FINAL PLAT

NORTHEAST ELEMENTARY SCHOOL ADDITION

RE: SUB 2002-71 -- One-Step Final Plat of Northeast Elementary School Addition

STAFF REPORT

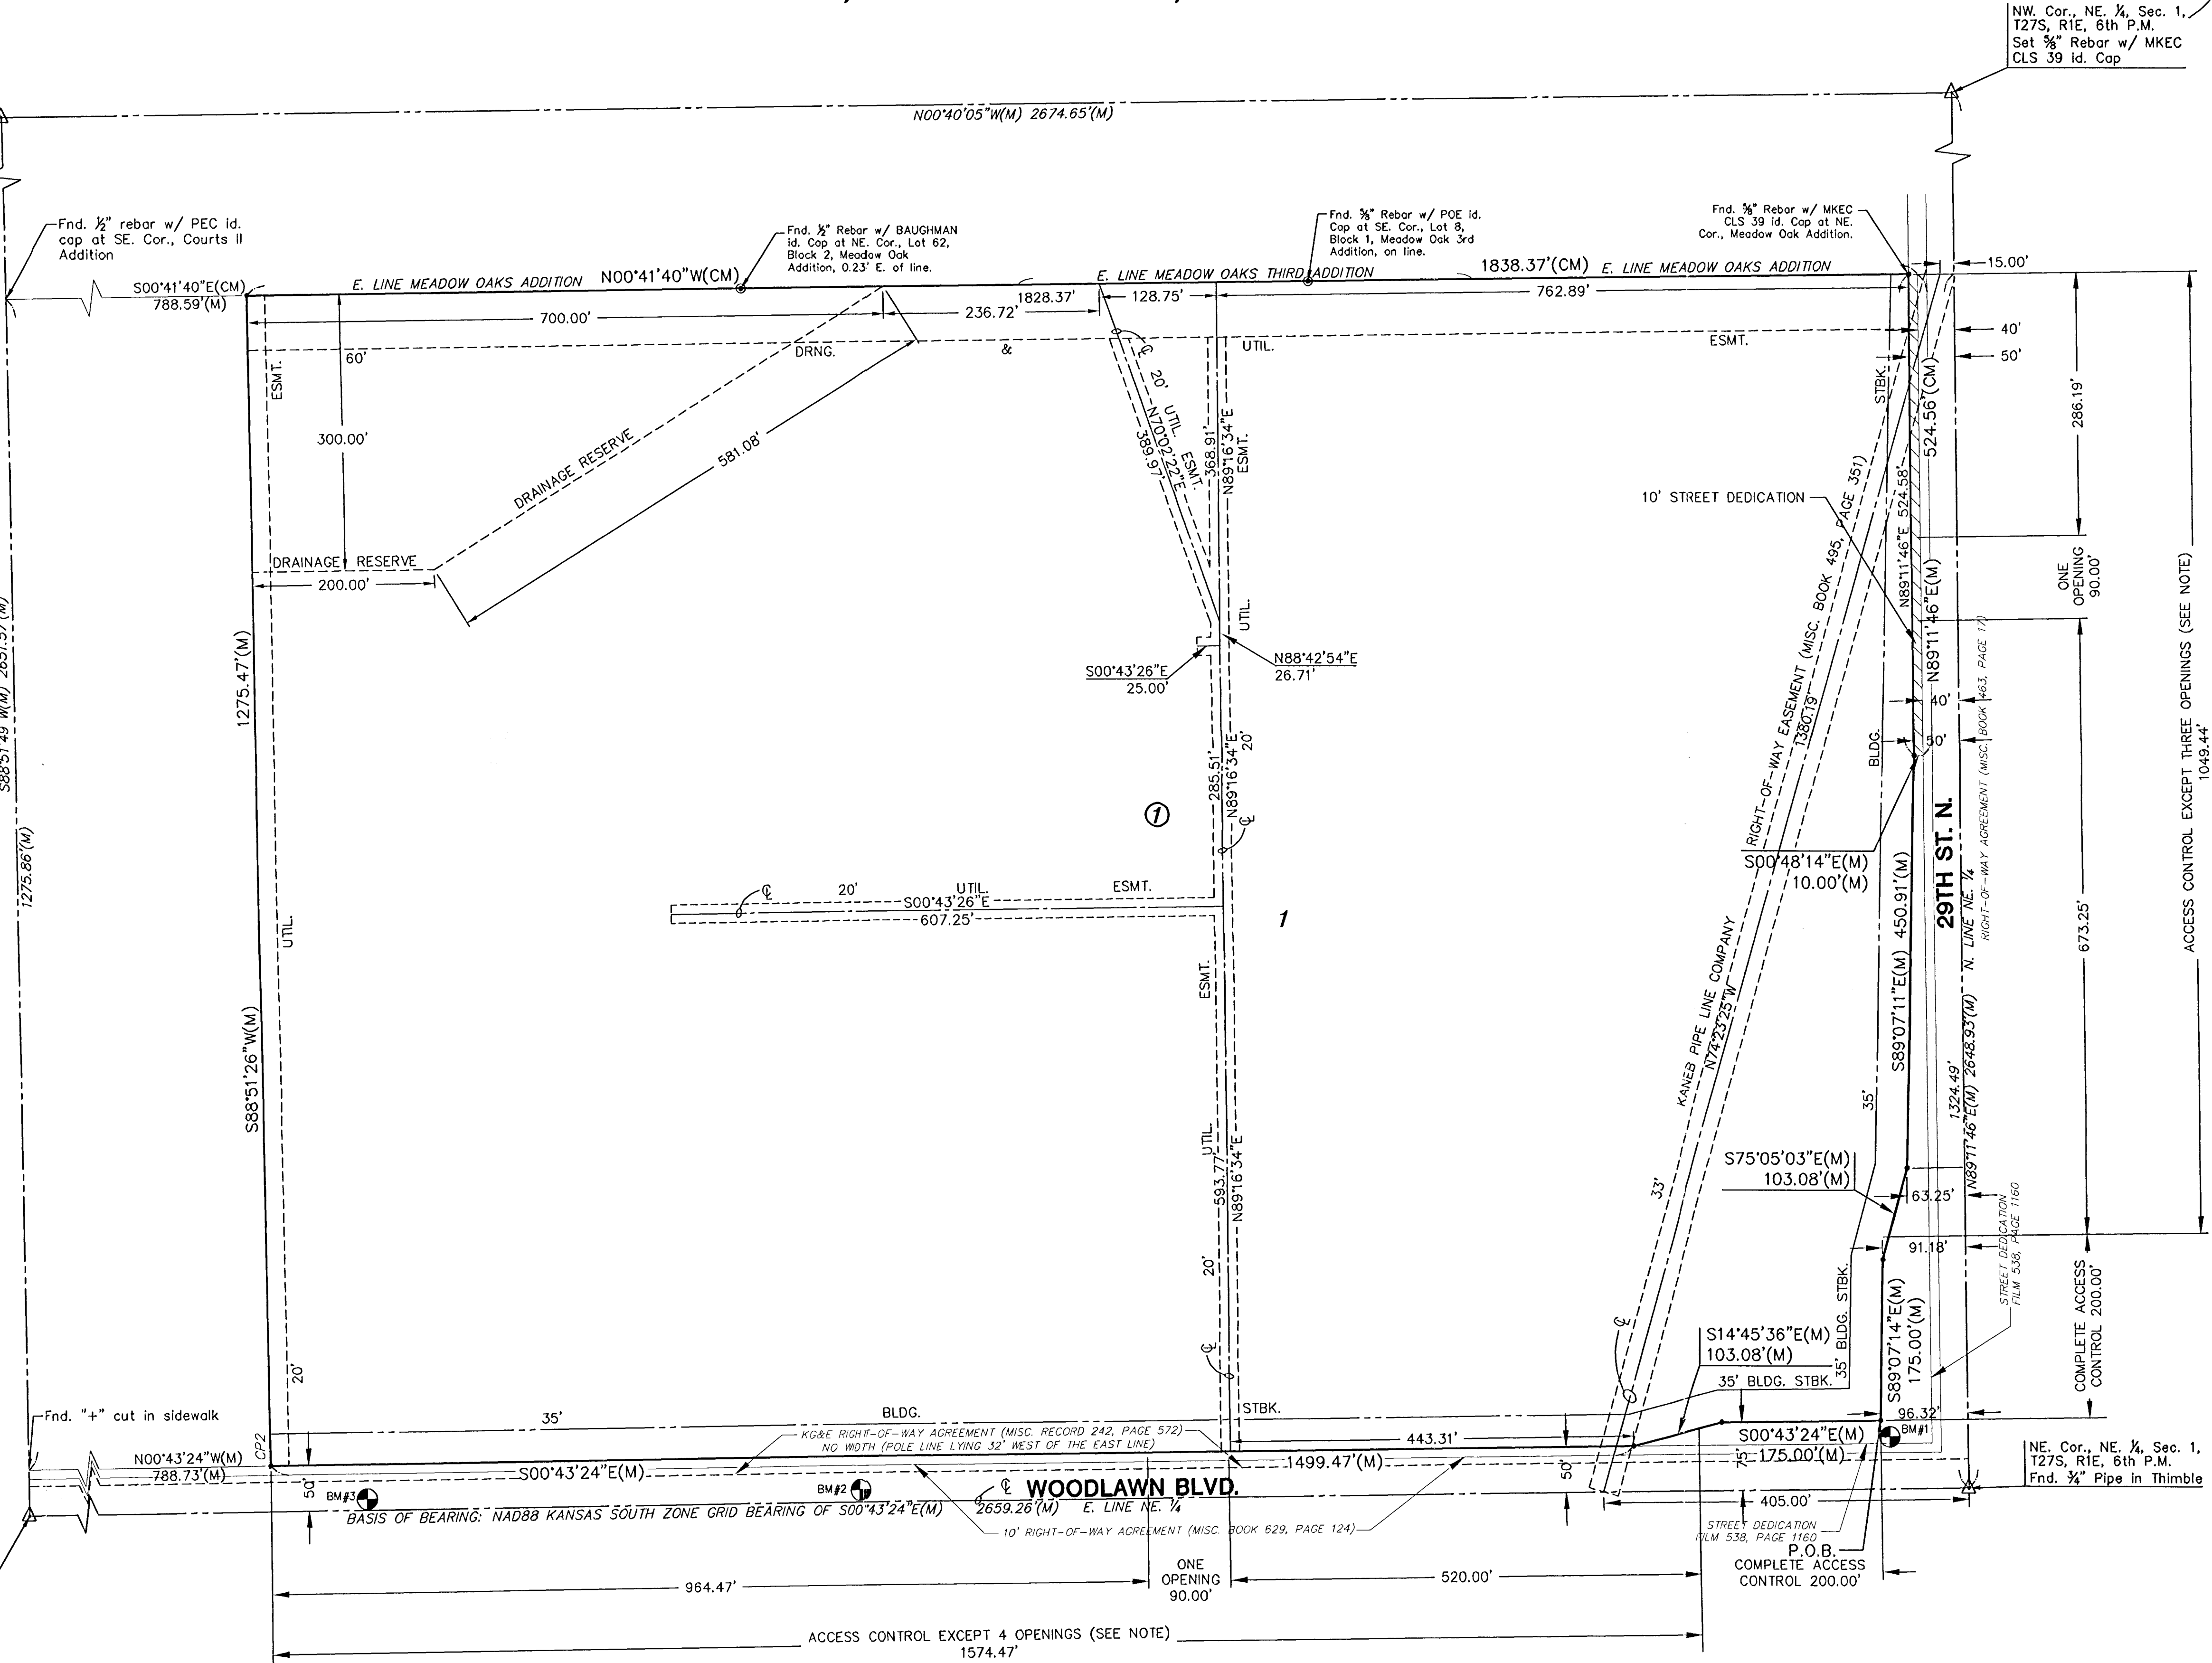
- C. The platting of minimum building elevations should be noted on the face of the plat and referenced in the plat's text.
- D. City Engineering needs to comment on the status of the applicant's drainage plan. A drainage reserve is needed in the southwest corner of the site. An off-site drainage easement is also needed.

- E. Traffic Engineering needs to comment on the access controls. The plat proposes four access openings along Woodlawn and three openings along 29th St. North. Distances should be shown for all segments of access control. The first opening with full turning movements along Woodlawn shall align with Pepperwood Road across Woodlawn. Spacing shall be 400 feet between the two subsequent openings; however the southernmost opening shall be at least 400 feet from the existing opening on the adjacent property to the south. Two openings are permitted along 29th St. North. The first opening with full turning movements along 29th St. North shall be at least 400 feet from the intersection; the second opening shall align with the existing opening across 29th St.

- F. Traffic Engineering needs to comment on the need for improvements to perimeter streets. Traffic Engineering has required a petition for left turns at the entrances from Woodlawn. Signalization may be required upon further review by the Traffic Engineer.

- H. The applicant's agent shall determine any setback requirements for the pipelines by researching the text of the pipeline agreements. If a setback from the pipeline easements is provided for in the pipeline easement agreements, it shall be indicated on the face of the plat.
